MONROE COUNTY, NEW YORK

ADDENDUM NO. 1

**MONROE COMMUNITY COLLEGE
2011 WINDOW REPLACEMENT AND CONCRETE/BRICK REPAIR
DECEMBER 2010
Bids Due: January 6, 2010 at 2:00 PM,**

Prepared by:
DeWolff Partnership Architects LLP
151 St. Paul Street
Rochester, New York 14604

3 THIRD FLOOR PLAN— WINDOW REPLACEMENT & CONCRETE REPAIR
1/16" = 1'-0"

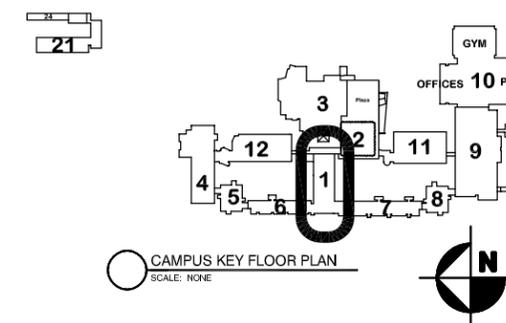
- 1-28 Furniture Notes:
ADD: FURNITURE NOTES: 1 THRU 3, AS FOUND ON DRAWINGS A-103, BUILDING 5, INCLUDING ADDENDUM NO. 1 REVISION TO FURNITURE NOTES ON DRAWINGS A-103.
- 1-29 Third Floor Plan 3/A-101:
ADD: REPLACE PARTIAL EAST THIRD FLOOR PLAN WITH ATTACHED PARTIAL EAST THIRD FLOOR PLAN AS FOUND ON ADDENDUM 1 DRAWING 1-29.

1 PARTIAL WALL SECTION - BLDG. 5 & 8
3/8"=1'-0"
(© CONFERENCE LOUNGE)

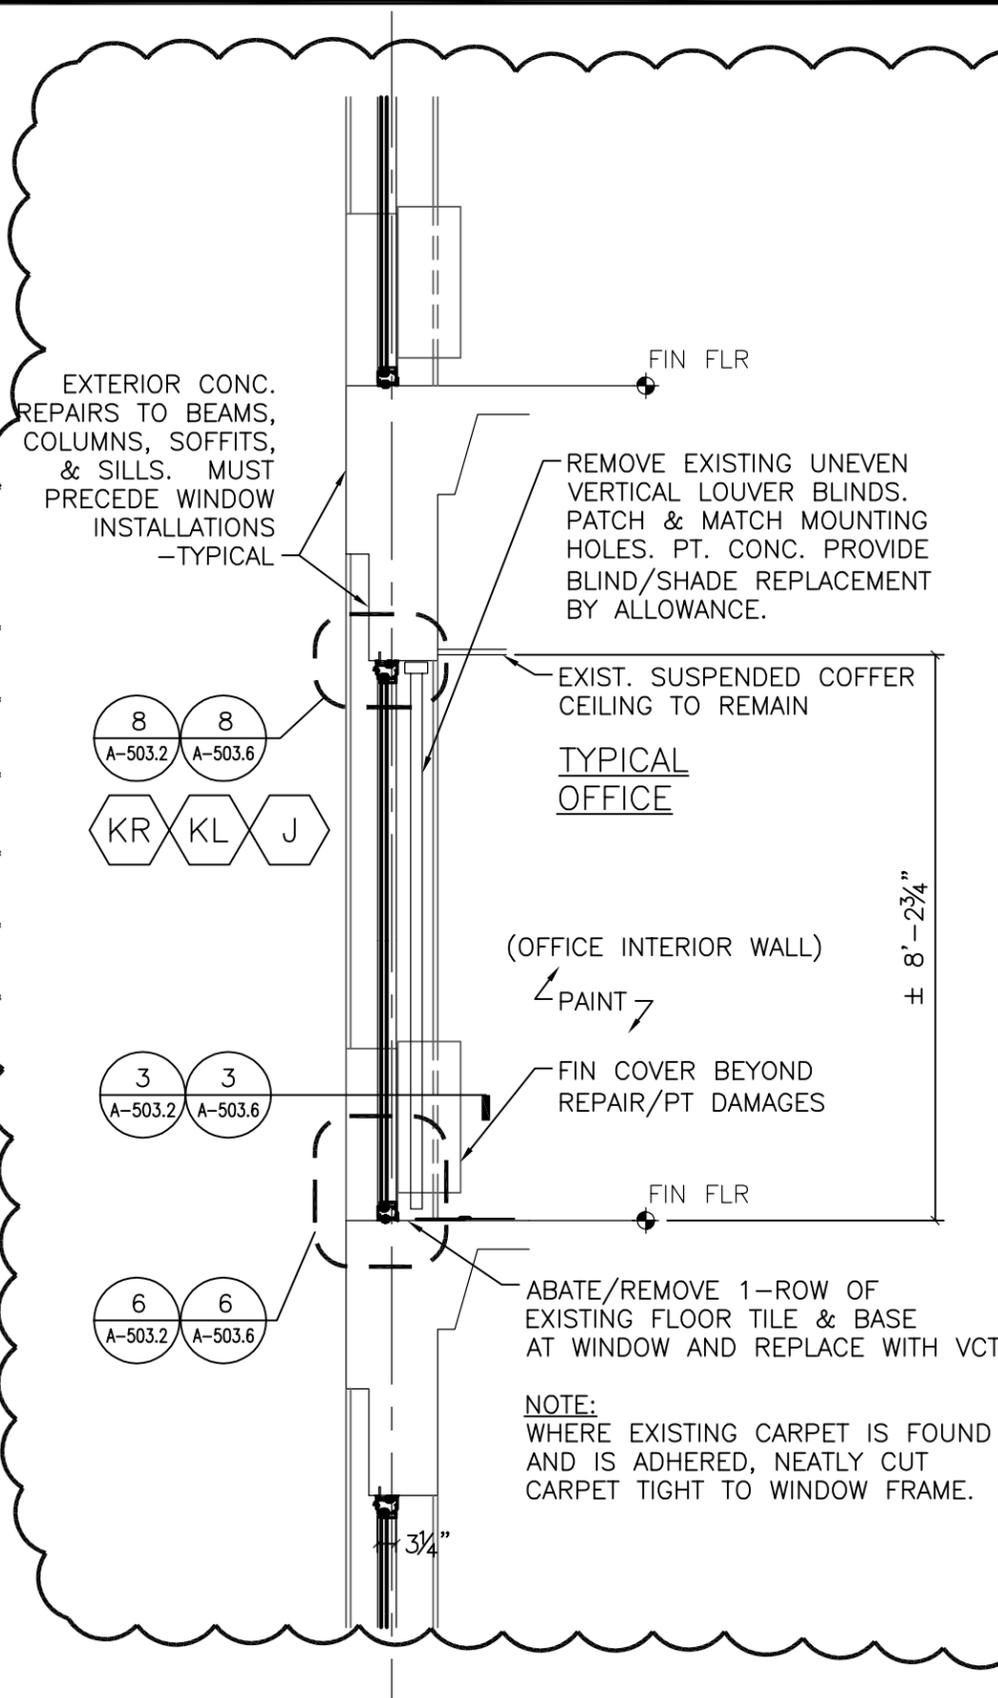
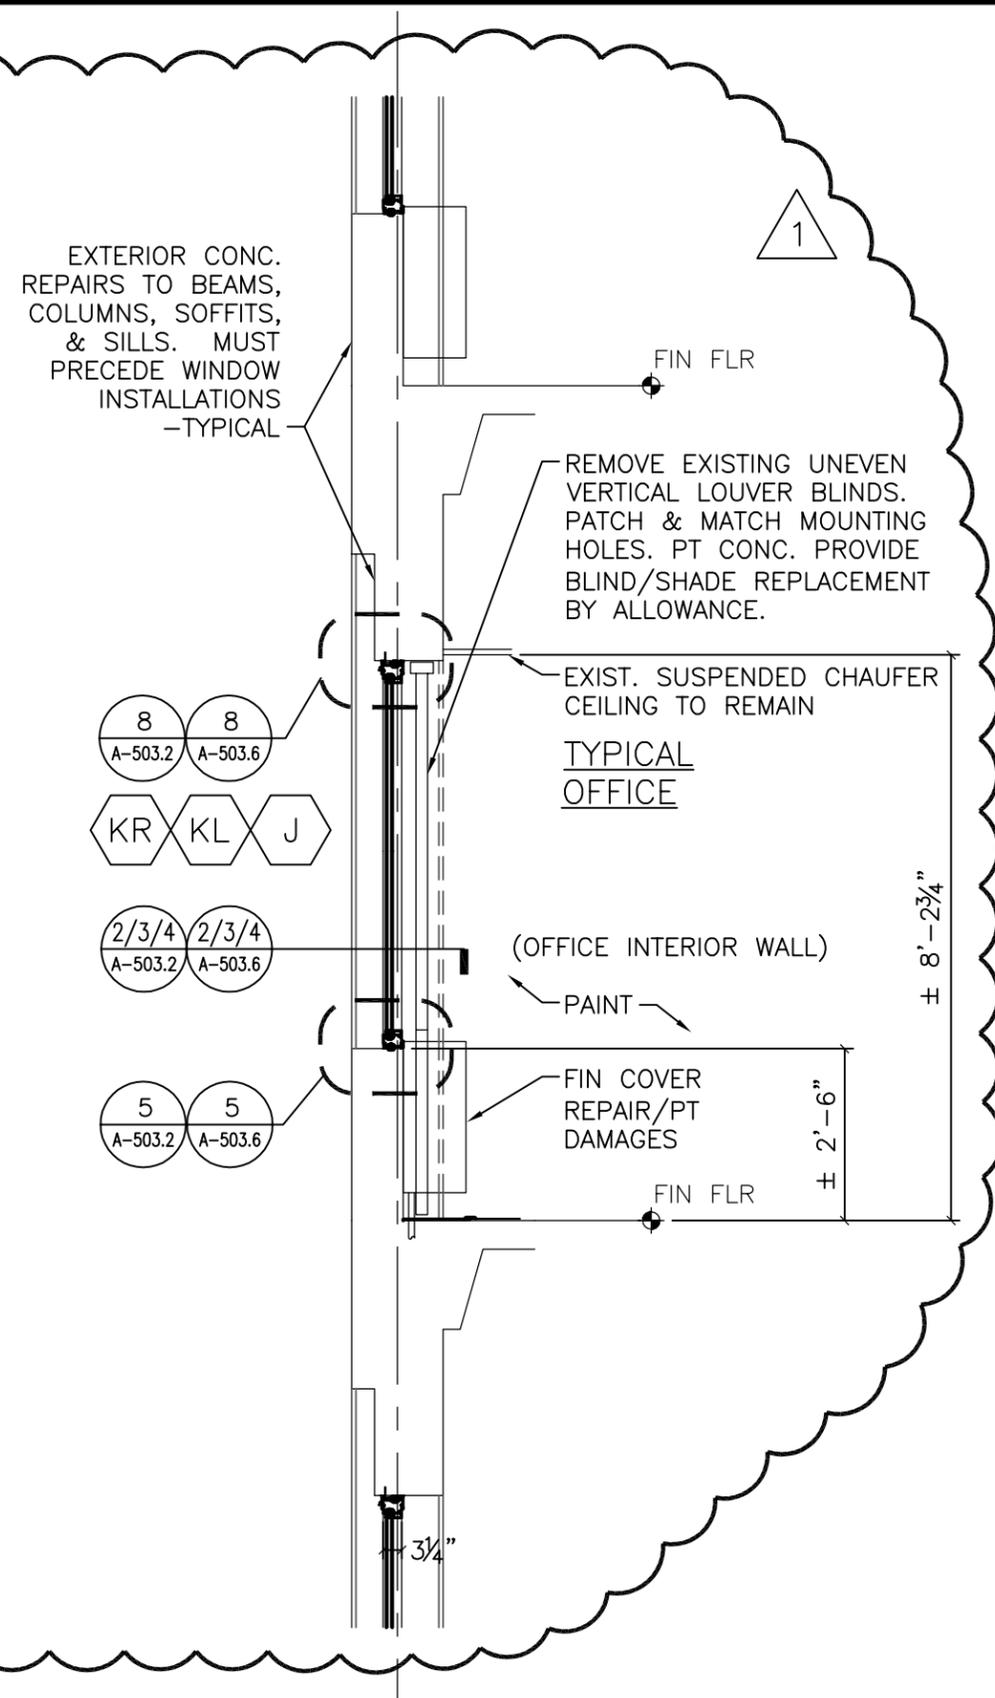
- 1-90 Partial Wall Section 1 & 2/A-403.1:
ADD: REPLACE PARTIAL WALL SECTIONS 1 & 2/A-403.1 WITH ATTACHED PARTIAL WALL SECTIONS 1 & 2 AS FOUND ON ADDENDUM 1 DRAWING 1-90. CLARIFICATION.
- 1-91 Partial Wall Section 3 & 4/A-403.1:
ADD: REPLACE PARTIAL WALL SECTIONS 3 & 4/A-403.1 WITH ATTACHED PARTIAL WALL SECTIONS 3 & 4 AS FOUND ON ADDENDUM 1 DRAWING 1-91. CLARIFICATION.

1 PARTIAL WALL SECTION - BLDG. 7
1/4" = 1'-0"

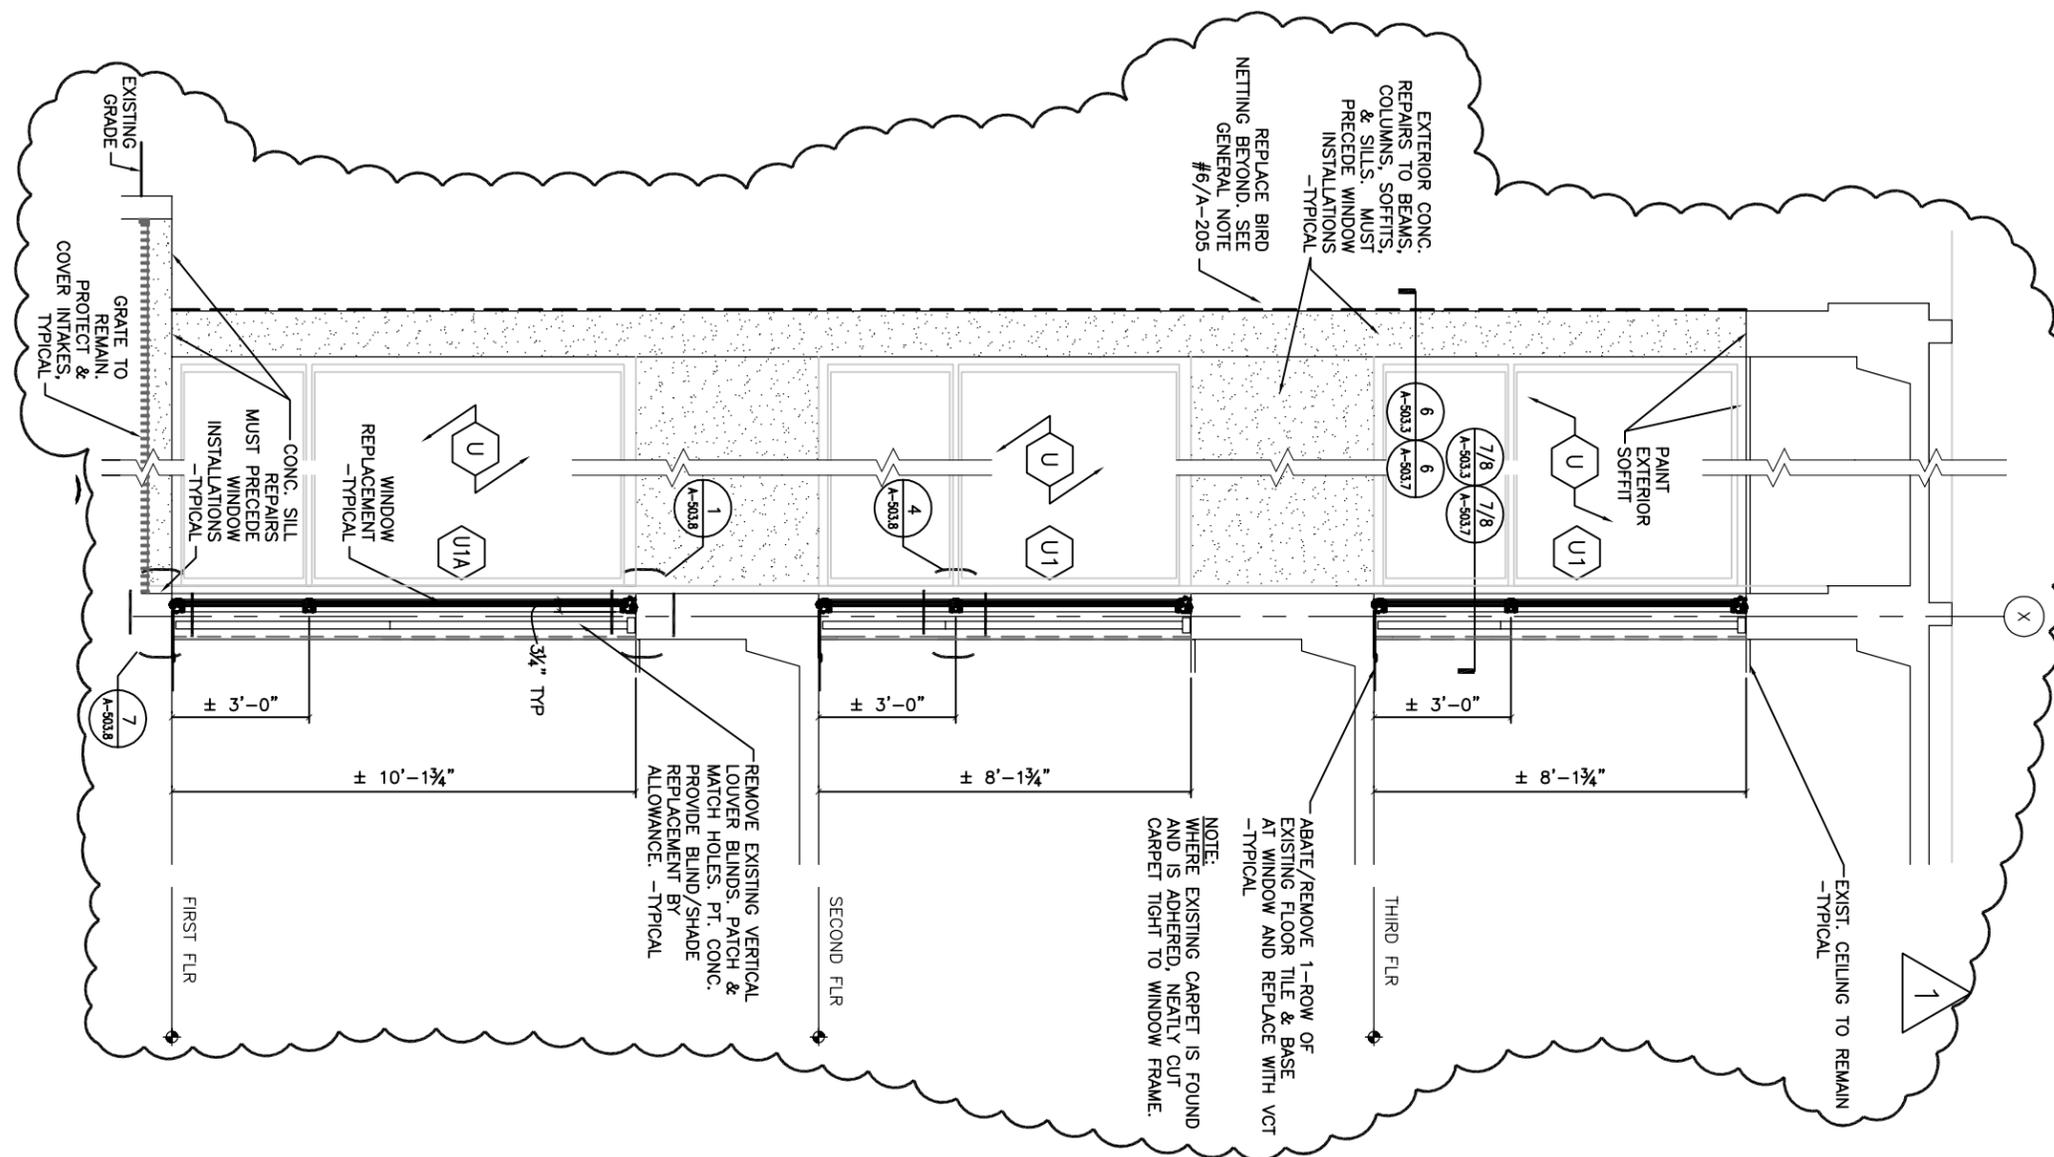
- 1-92 Partial Wall Section 1/A-403.2:
ADD: REPLACE PARTIAL WALL SECTIONS 1/A-403.2 WITH ATTACHED PARTIAL WALL SECTIONS 1 AS FOUND ON ADDENDUM 1 DRAWING 1-92. CLARIFICATION.

4 GLAZING HEAD - TYPICAL CONCRETE WALL
SCALE: 1 1/2" = 1'-0" REFERENCE LOCATION BOARD ROOM & CONF./LOUNGE

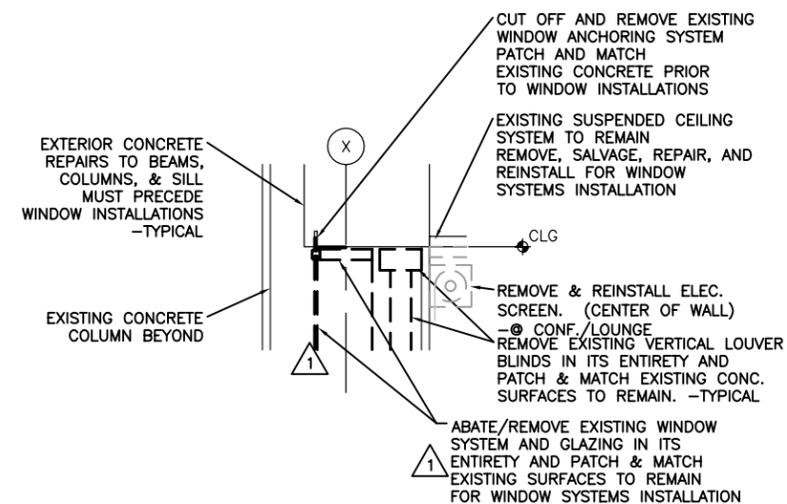
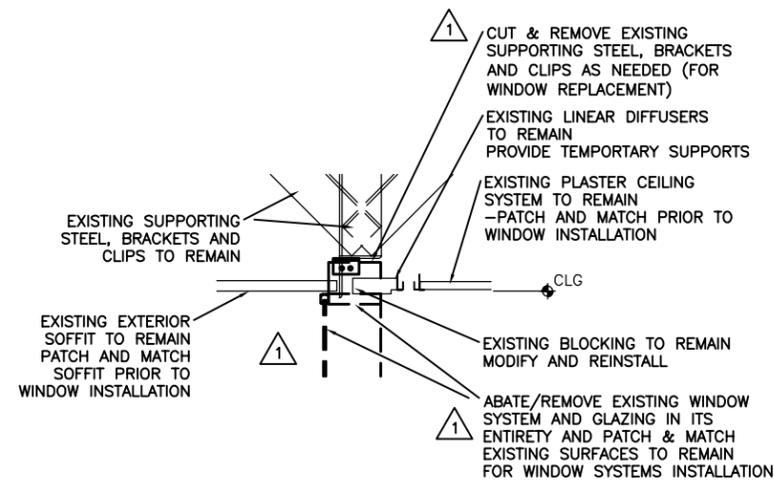
- 1-93 Detail 3/A-503:
DELETE: DETAIL 3/A-503 – NOT USED.
- 1-94 Detail 5/A-503:
DELETE: DETAIL 5/A-503 – NOT USED.
- 1-95 Details 4 & 6 /A-503:
ADD: REPLACE DETAILS 4 & 6/A-503 WITH ATTACHED DETAILS 4 & 6, AS FOUND ON ADDENDUM 1 DRAWING 1-95. CLARIFICATION.
- 1-96 Details 7, 8 & 9 /A-503:
ADD: REPLACE DETAILS 7, 8 & 9/A-503 WITH ATTACHED DETAILS 4 & 6, AS FOUND ON ADDENDUM 1 DRAWING 1-96. CLARIFICATION.

7 DOOR THRESHOLD @ PRESIDENT'S OFFICE
SCALE: 1 1/2" = 1'-0"
SIMILAR @ CONF./LOUNGE

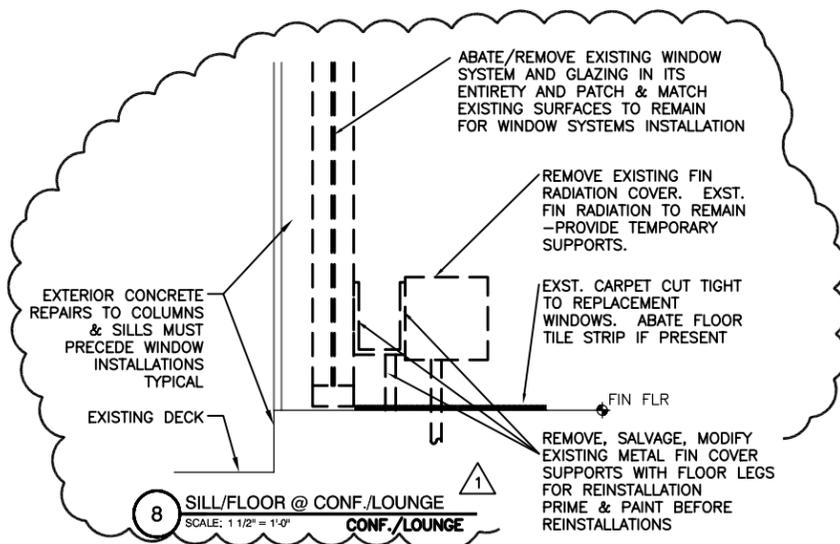
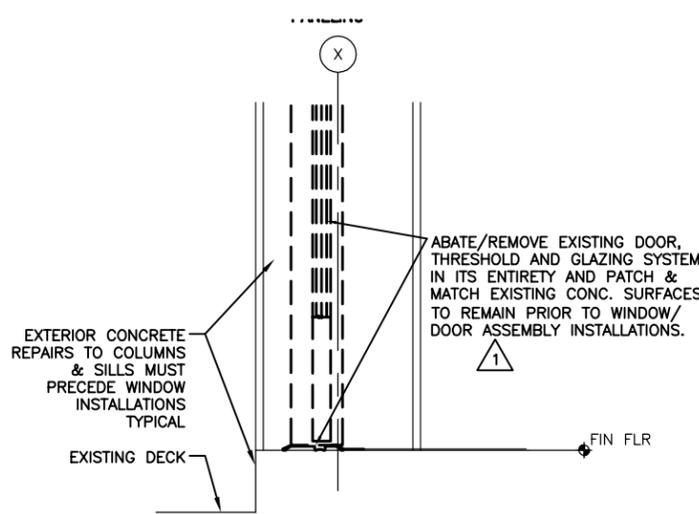
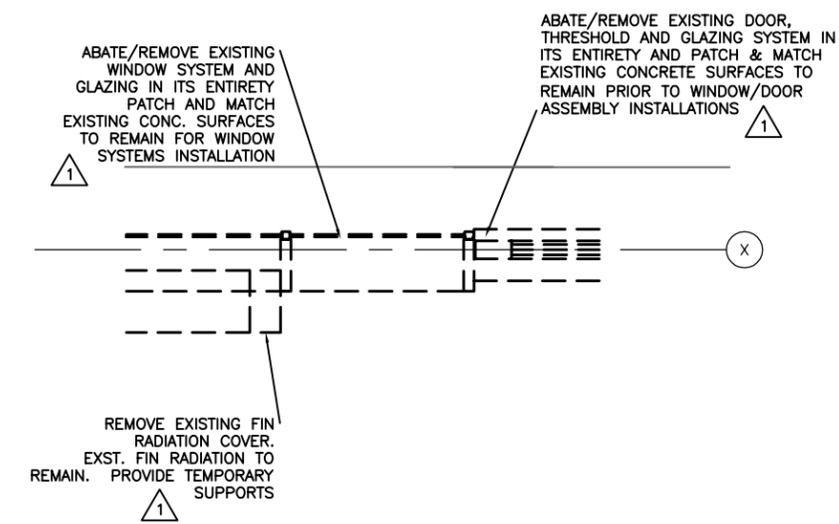
- 1-101 Details 6, 7 & 8 /A-503.1:
ADD: REPLACE DETAILS 6, 7A-503.1 AND ADD DETAIL 8/A-503.1 WITH ATTACHED DETAILS 6, 7 & 8, AS FOUND ON ADDENDUM 1 DRAWING 1-101. CLARIFICATION.

SHEET TITLE
BLDG. 6 & 7
TYPICAL WINDOW
DETAILS

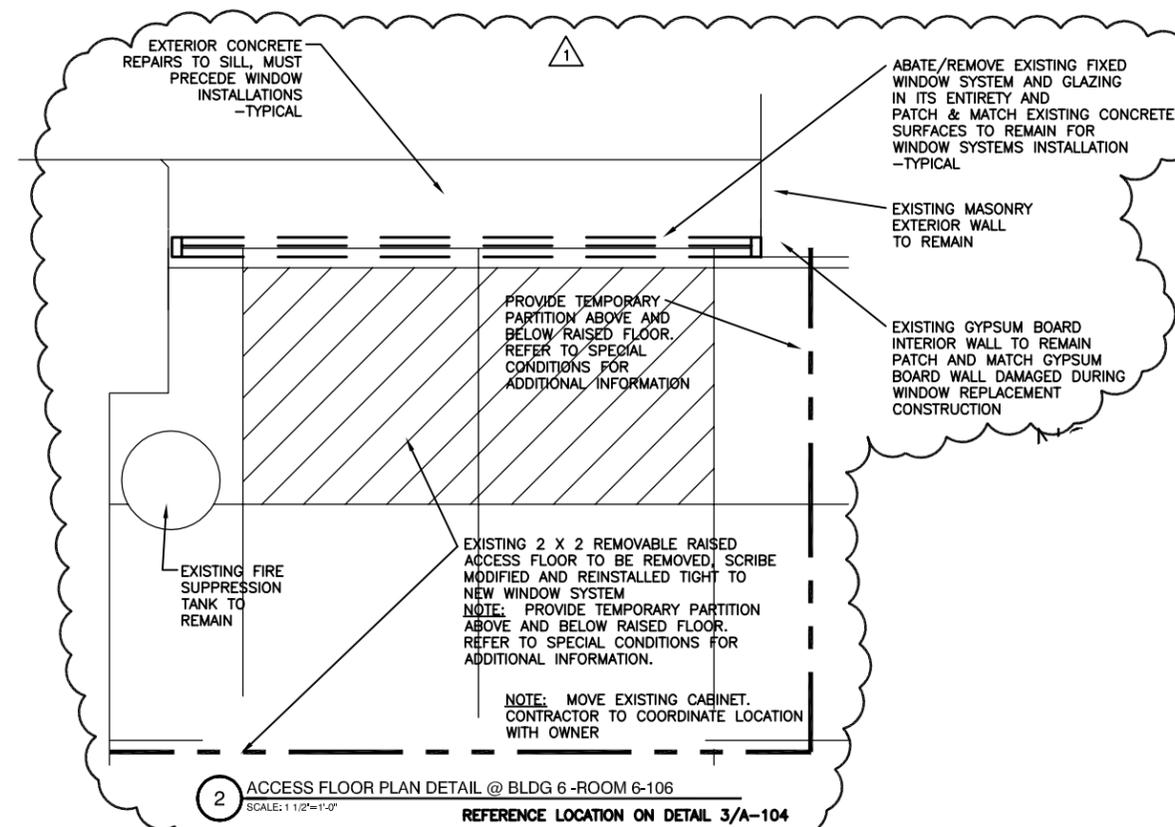
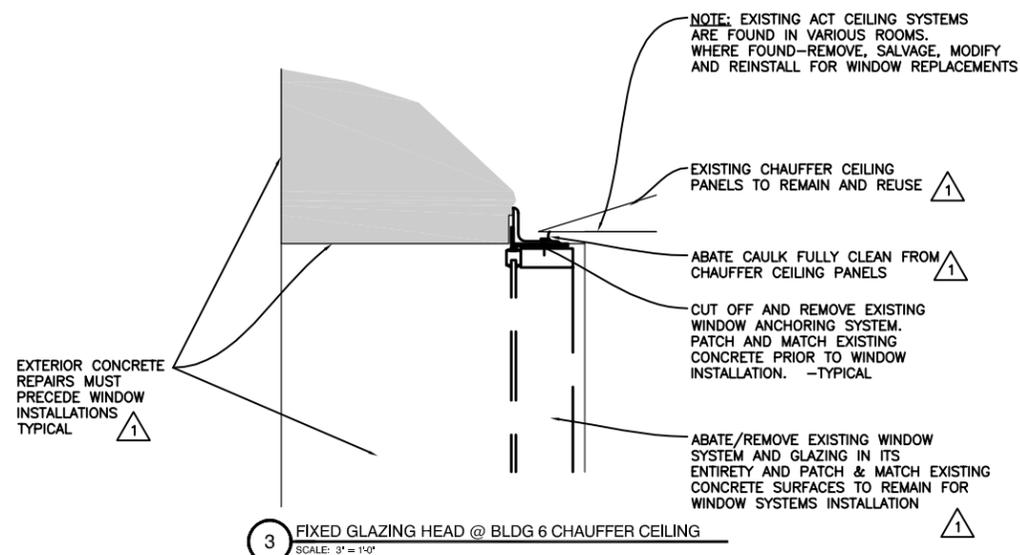
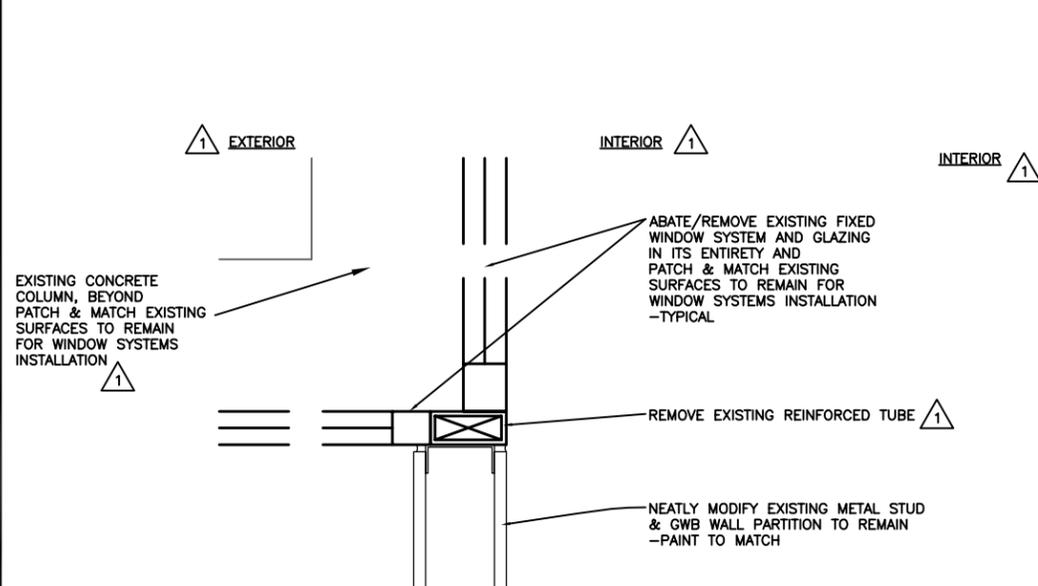
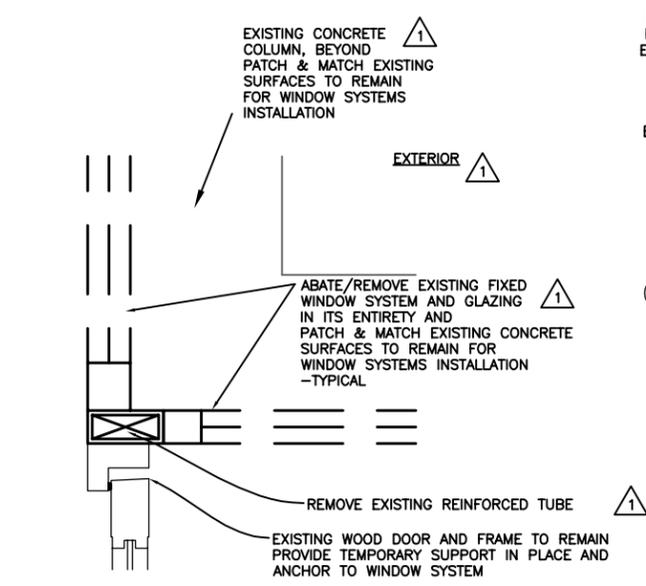
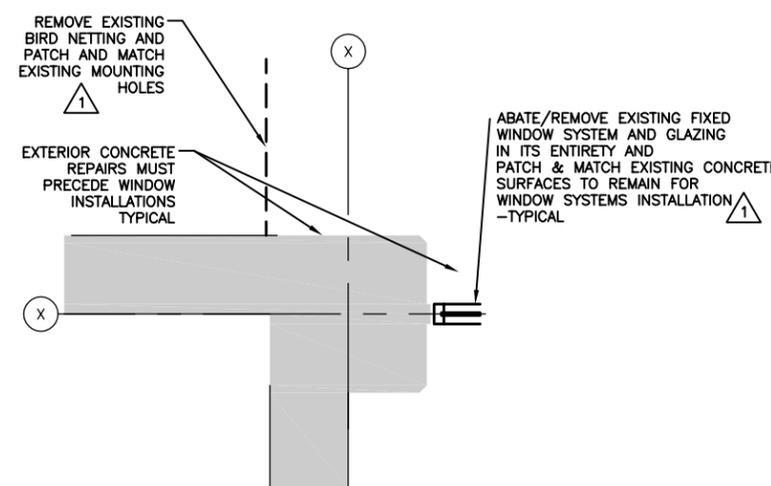
- 1-104 Details 2, 3, 4, 6, 7 & 8 /A-503.3:
ADD: REPLACE DETAILS 2, 3, 4, 6, 7 & 8 /A-503.3 WITH ATTACHED DETAILS 2, 3, 4, 6, 7 & 8, AS FOUND ON ADDENDUM 1 DRAWING 1-104. CLARIFICATION.
